Access Compliance Report

Public Rights-of-Way

(Curb Ramps)

Intersection ID: 51442	Main Street: TAMARRON_DR	Cross Street: KRISTENS_MARE_DR	Location: E
ADA ID: 8CB35F855A04	Ramp Type: Perp	Initial Pass/Fail: Fail	Overall Compliance: No
Severity Score: 12.5			
Codes/Mitigation Info/Possible Solution		Field Measurements/Component Compliance

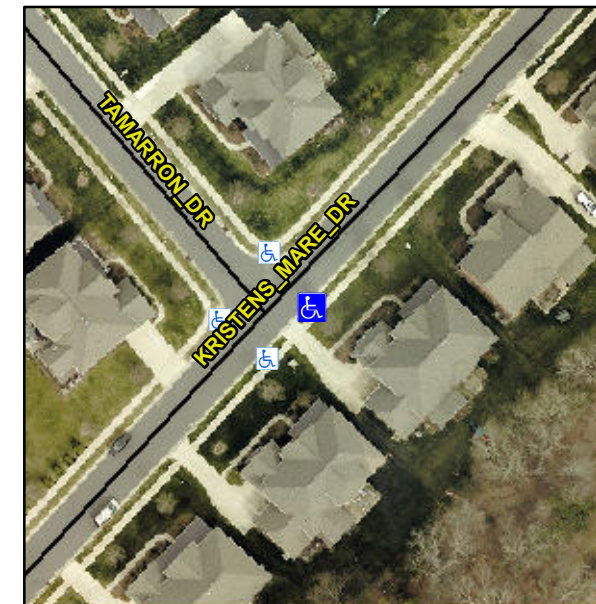
Not Found, R304.2.2

Compliance	Description	Data	Compliance	Description	Data
N/A	Ramp Length (in)	46.0	No	Ramp Slope (%)	10.1
Yes	Ramp Width (in)	48.0	Yes	Ramp XSlope (%)	1.2
N/A	Flare Type LT	N/A	N/A	Flare Type RT	N/A
N/A	Flare Slope LT (%)	N/A	N/A	Flare Slope RT (%)	N/A
N/A	Flare Traversable LT?	N/A	N/A	Flare Traversable RT?	N/A
N/A	Landing Length (in)	N/A	N/A	DWS Provided?	N/A
N/A	Landing Width (in)	N/A	N/A	DWS Contrast?	N/A
N/A	Landing Slope (%)	N/A	N/A	DWS Length (in)	N/A
N/A	Landing X Slope (%)	N/A	N/A	DWS Full Width?	N/A
N/A	Landing Curb? (Y/N)	N/A	N/A	DWS Offset (in)	N/A
N/A	Shared Landing?	N/A			
N/A	Gutter Ponding?	N/A	N/A	Gutter Slope (%)	N/A
N/A	Gutter Lip Ht (in)	N/A	N/A	Gutter X Slope (%)	N/A
N/A	Painted X Walk1?	No	N/A	Painted X Walk2?	N/A
	X Walk 1 Direction	To NW		X Walk 2 Direction	N/A
N/A	X Walk 1 Width (in)	N/A	N/A	X Walk 2 Width (in)	N/A
	X Walk 1 Slope (%)	4.1		X Walk 2 Slope (%)	N/A
	X Walk 1 X Slope (%)	1.8		X Walk 2 X Slope (%)	N/A

Remove & Replace Entire Ramp.
